**ONSITE SEWAGE DISPOSAL SYSTEM**

PROPERTY ADDRESS: 14939 Victory Lane

SUBDIVISION: Meriwether Farm

I've reviewed the BAT plan for Meriwether lot 5 and have some comments:

**PRE-CONSTRUCTION:**

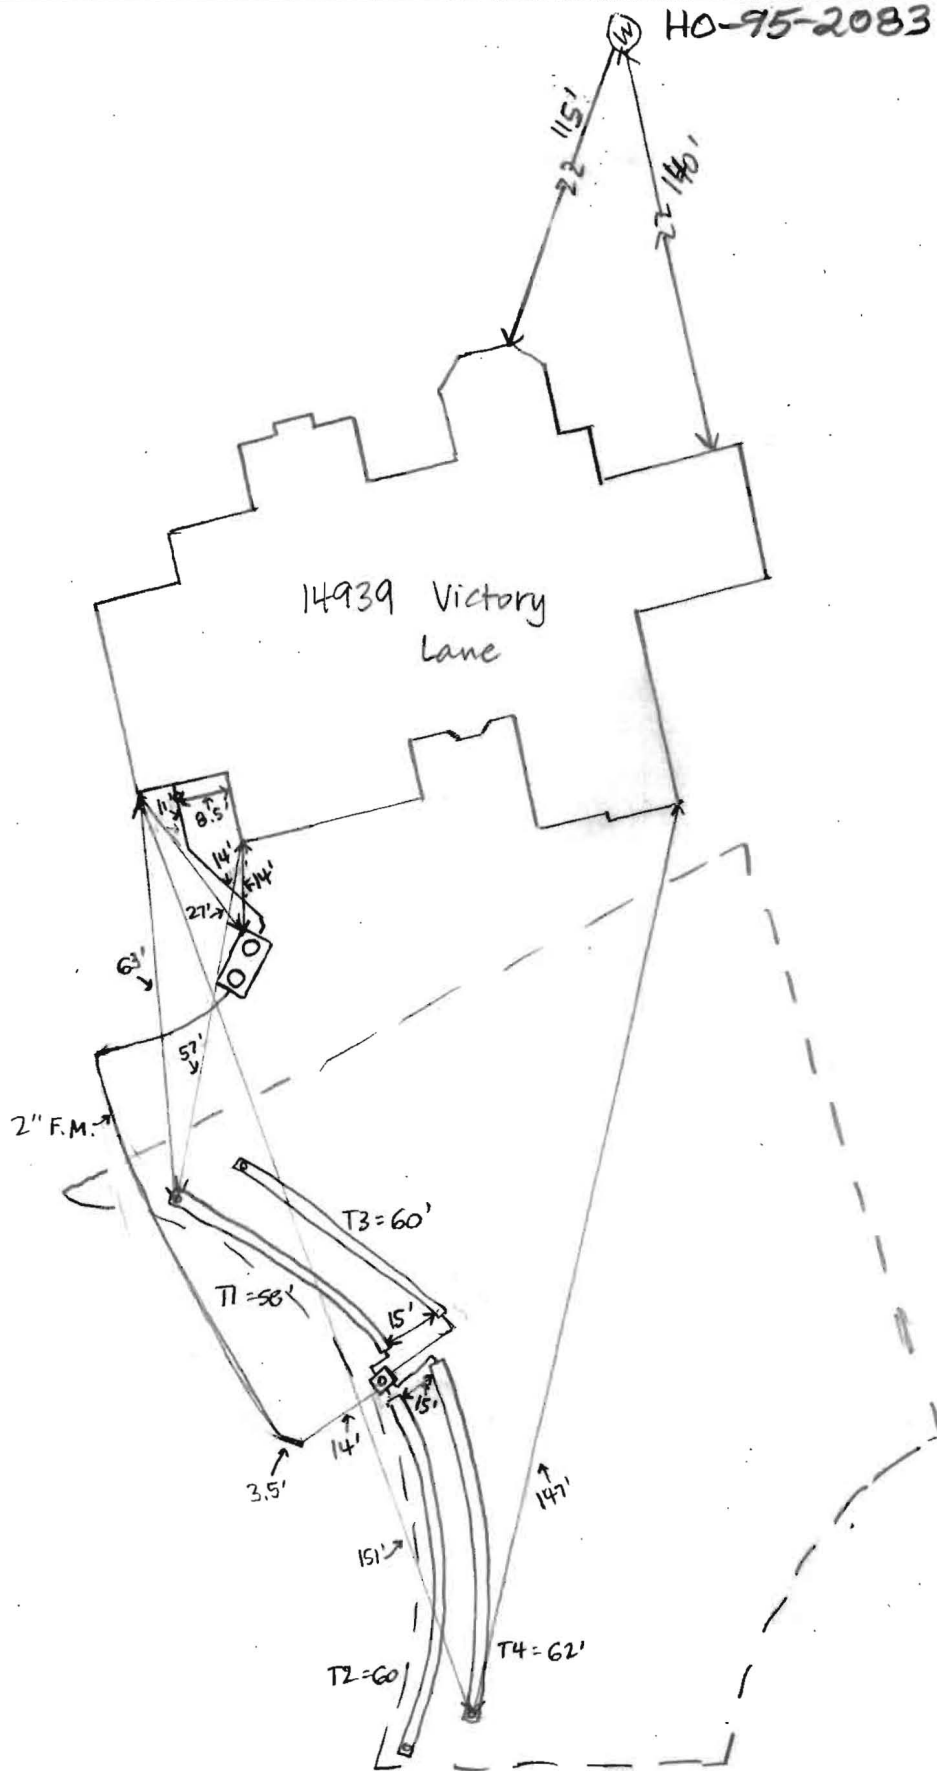
1/9/2015 Install trenches similar to plan. Builder wants to move the septic tank to the front of the house to avoid gas and electric lines. (BB)

**From:** Williams, Jeffrey  
**Sent:** Friday, April 25, 2014 3:13 PM  
**To:** 'Ryan Ketner'; 'Michael Boyce'  
**Subject:** Meriwether lot 5

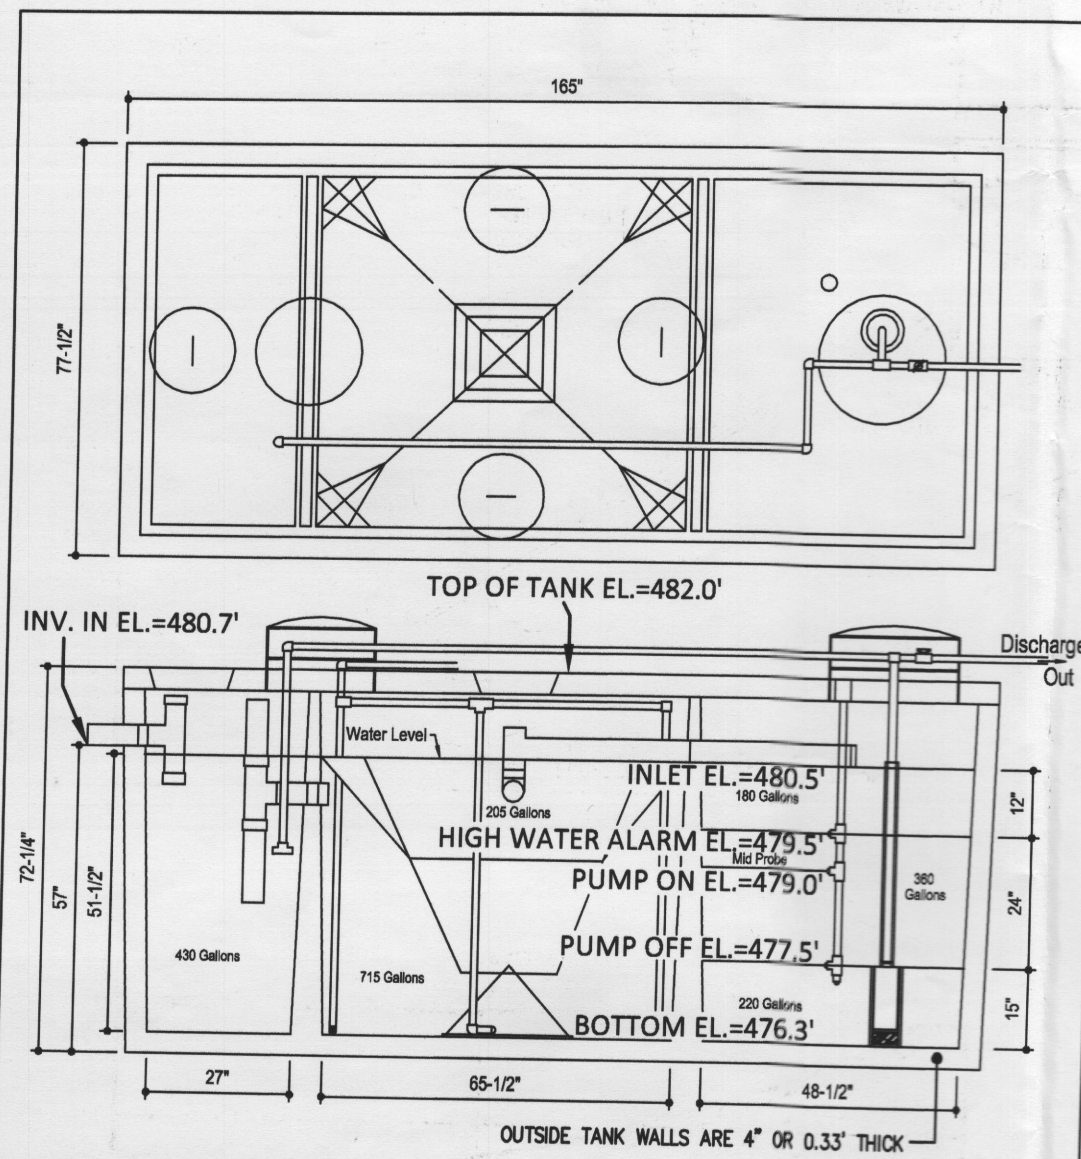
- Can we move the BAT unit further up the hill away from the level spreader? It looks like we have some fall from the house to work with that we can get it up the hill a ways. As far as you can go and still keep at least 1% fall would be preferable
- We'd prefer to see the d-box in the same spot, but split the trenches into smaller lengths so that more of the upper portion of the reserve can be utilized. It looks like we could get two 50+' trenches on each contour.
- The plan should indicate the true flow rate of the pump chosen based on the head and then the runtime modified accordingly. In this case, the pump will give you 28gpm at your head. With that flow, you could set a runtime of 2 minutes for a 56g dose, which will be fine here. We recently discovered that a dose around 50g is preferable when going to a d-box. Thanks.
